Project	IEEE 802.16 Broadband Wireless Access Working Group < http://ieee802.org/16 >	
Title	Clarification on interleaver for vertically encoded MIMO	
Date Submitted	2005-01-11	
Source(s)	Qinghua Li, Sumeet Sandhu, Xintian Eddie Lin, Alexei Davydov, Uri Perlmutter, Nageen Himayat, Minnie Ho, Randall Schwartz, Jose Puthenkulam Intel Corporation	qinghua.li@intel.com Voice: +1-408-765-9698
Re:		
Abstract		
Purpose	Adoption of proposed changes into P802.16e Crossed out indicates deleted text, <u>underlined blue indicates new text change to the Standard</u>	
Notice	This document has been prepared to assist IEEE 802.16. It is offered as a basis for discussion and is not binding on the contributing individual(s) or organization(s). The material in this document is subject to change in form and content after further study. The contributor(s) reserve(s) the right to add, amend or withdraw material contained herein.

Clarification on Interleaver for Vertically Encoded MIMO

Figure 254a Illustration of Matrix C with vertically encoding for optional zones in DL.

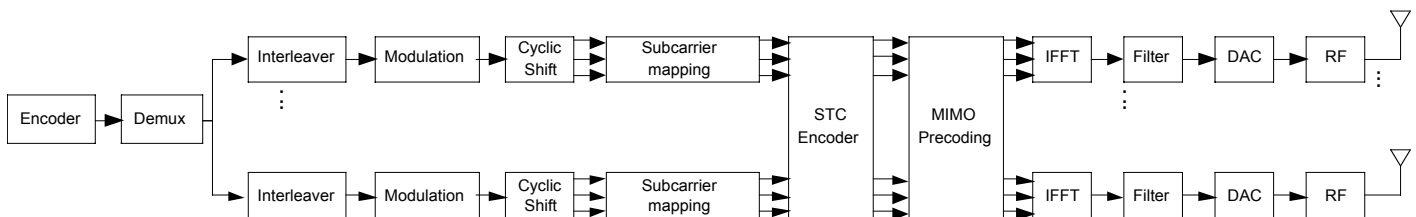
Added section 8.4.8.10 at line 33 on page 362 of [1] as follows

Figure 254a illustrates a transmitter for vertically encoded MIMO, where there are N_d data streams. The punctured code bits are distributed into N_d modulation chains. Each chain interleaves and modulates the distributed bits using the interleaving and permutation schemes specified for SISO transmission. The modulated symbols are circularly shifted by an increase number of subcarriers on each chain as follows. The shift steps are $0, 1, \dots, N_d-1$ for chain $1, \dots, N_d$ respectively.
